## SERVICE BULLETIN

# Replacement of oil filter for ROTAX® Engine Type 912 i, 912 and 914 (Series)

ATA System: 79-00-00 Lubrication system

Fig. 1  
Oil filter

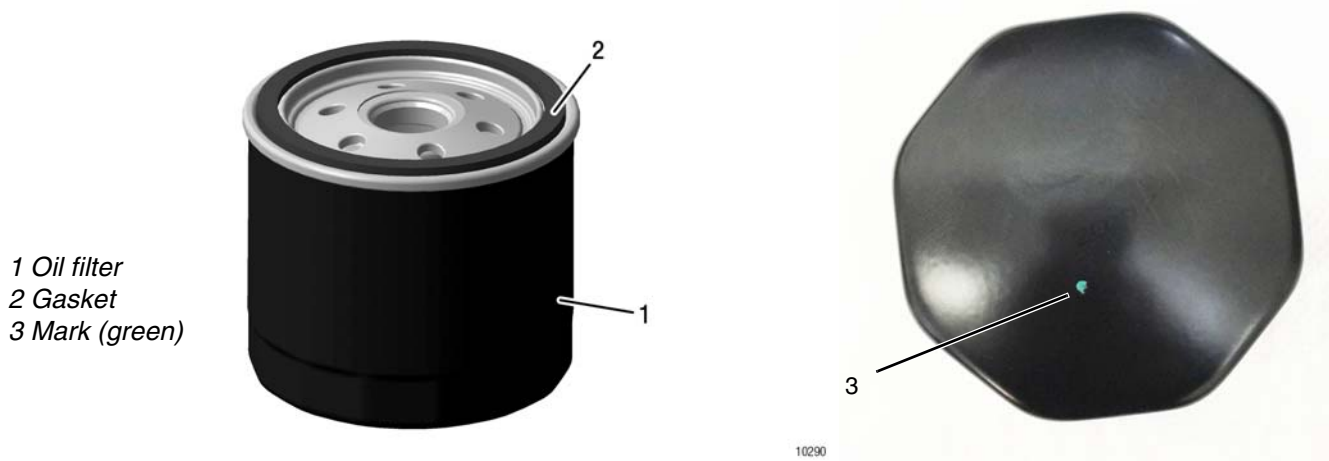
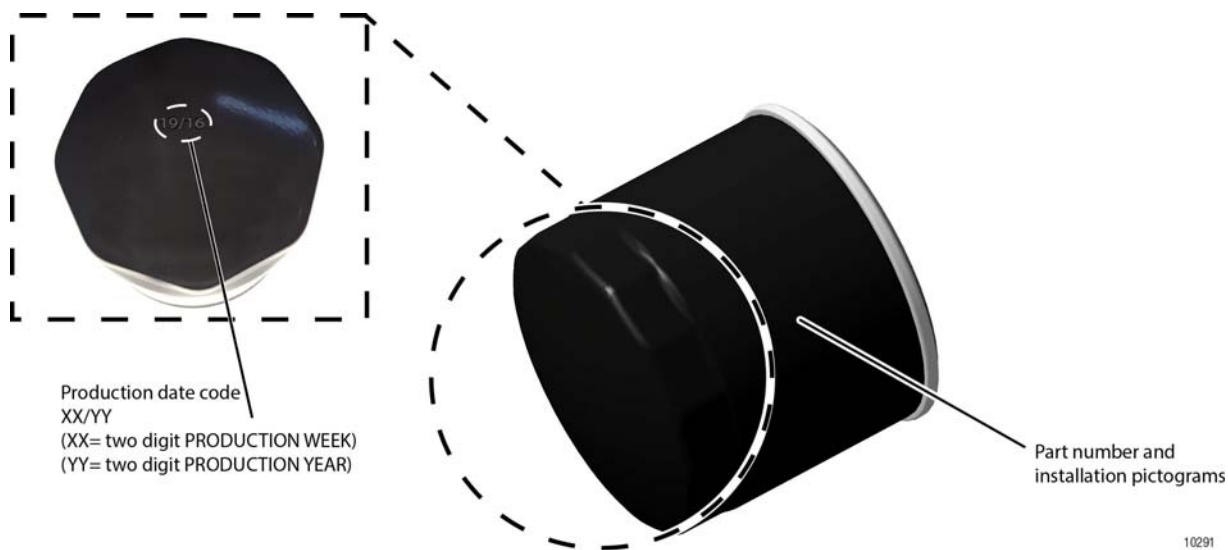
The above engines have been fitted by the manufacturer with an oil filter part no. 825016 with a production date code 10/17 up to 38/17 and have no green mark see Fig. 1).

All engines are affected, which have been equipped with an oil filter part no. 825016 (with a production date code from 10/17 up to 38/17) during engine repair, maintenance or general overhaul as of June 8<sup>th</sup>, 2017 to October 31<sup>st</sup>, 2017 and have no green mark. see Fig. 1).

Due to deviations in the manufacturing process of the oil filter's gasket, cracks in the gasket may have occurred. In rare cases, these deficiencies might lead to oil leakage in the area of the oil filter gasket.

Step	Procedure
1	Check the engine logbook and maintenance documentation or shipping documents to see if this Service Bulletin has already been accomplished.
2	<p>Check whether the affected oil filter shows a green mark on the crown of oil filter (as illustrated in Fig. 1) (same area as production date code).</p> <ul style="list-style-type: none"> <li>- green mark is present: this oil filter is OK as it has already been tested by the supplier and can be used even though the production date code is from 10/17 to 38/17. No further actions are required.</li> <li>- green mark NOT present: this oil filter is NOT OK, please follow the instructions in section 3.2).</li> </ul> <p>NOTE: If production date code is not easy to read, use a proper means of light (e.g. flashlight directed at a proper angle onto the oil filter crown etc.) for better visibility of the coding imprint.</p>

Step	Procedure
1	Remove the affected oil filter according to the Maintenance Manual Line.
2	Install the new oil filter according to the Maintenance Manual Line.

Step	Procedure
1	Quarantine and/or remove affected filters from your inventory. Mark as unserviceable and return F.O.B. to your ROTAX® Authorized Distributor or their independent Service Centers.
